Sequoyah Nuclear Plant, Units 1 and 2
Renewed Facility License Nos. DPR-77 and DPR-79
NRC Docket Nos. 50-327 and 50-328

Subject: **Application to Revise Sequoyah Nuclear Plant Units 1 and 2 Updated Final Safety Analysis Report Regarding Changes to Hydrologic Analysis - Response to Request for Additional Information (TS-19-02) (EPID L-2020-LLA-0004)**

Enclosure 1
Response to NRC IQVB Request for Additional Information

Enclosure 3
Gridded PMP Development Calculation
(Executable Files Removed)

Figure No. 1

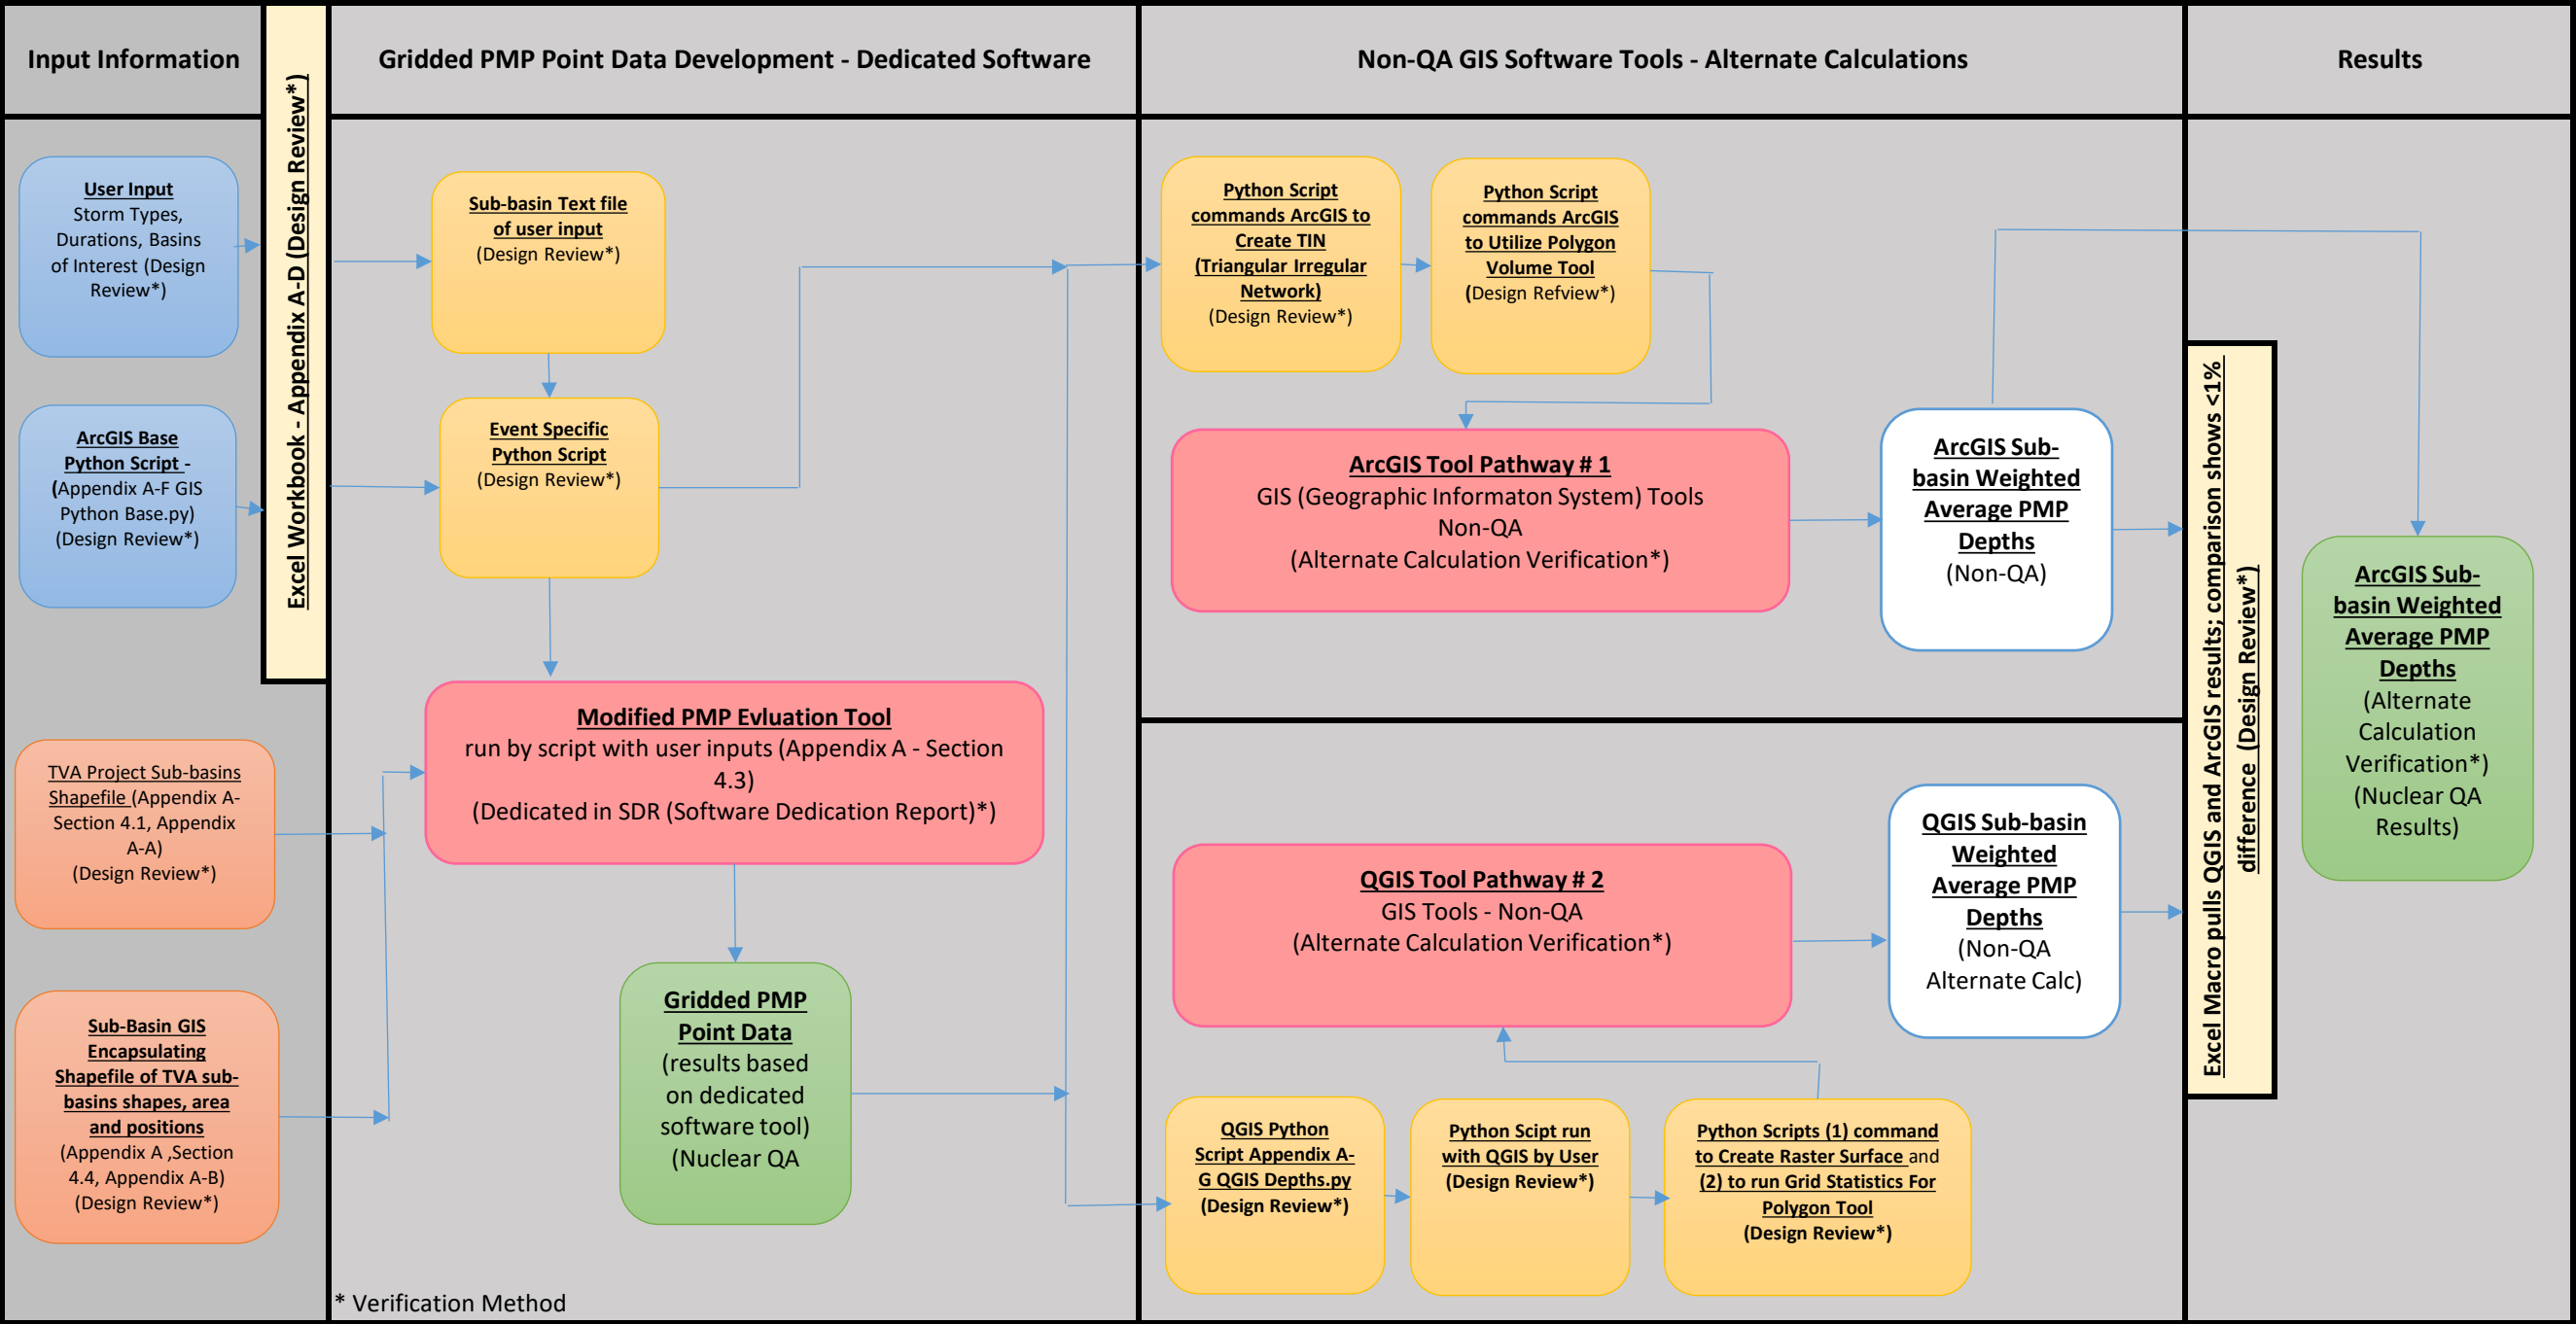
- a) Information to clarify how hand calculations are used to verify the outputs of any of the tools used, including the PMP Evaluation Tool, ArcGIS and QGIS.*

In Reference 1, TVA provided general information in regard to the methodologies used to perform alternate calculations. This general information stated that hand calculations could be used as an alternate calculation. However, in the development of the basin average PMP depths, hand calculations were not used to check the results of the PMP Evaluation tool or the ArcGIS and the QGIS tools outside of the PMP Evaluation Tool. Calculations made within ArcGIS outside of the PMP Evaluation Tool were checked via alternate methodologies within QGIS by comparison of the average basin rainfall depth determined by the two different GIS methodologies as described in the gridded PMP development calculation (Enclosure 3). The Microsoft Excel workbook and those portions of the Python scripting outside the PMP Evaluation tool were checked and design verified under the Barge QA program. Detailed descriptions of the Microsoft Excel workbook and Python scripting are provided in Appendix A of Enclosure 3.

The PMP Evaluation Tool has been dedicated utilizing the Barge Nuclear QA program through rigorous testing and research for features of the software by completion of a series of test cases. These results along with the limitation of the PMP Evaluation Tool software are documented in the SDR (Enclosure 2). Therefore, Barge concluded the PMP Evaluation Tool software is dedicated and may be used as pre-verified software.

Figure 1 shows the key elements in the development of the gridded PMP and to note the verification method for each element.
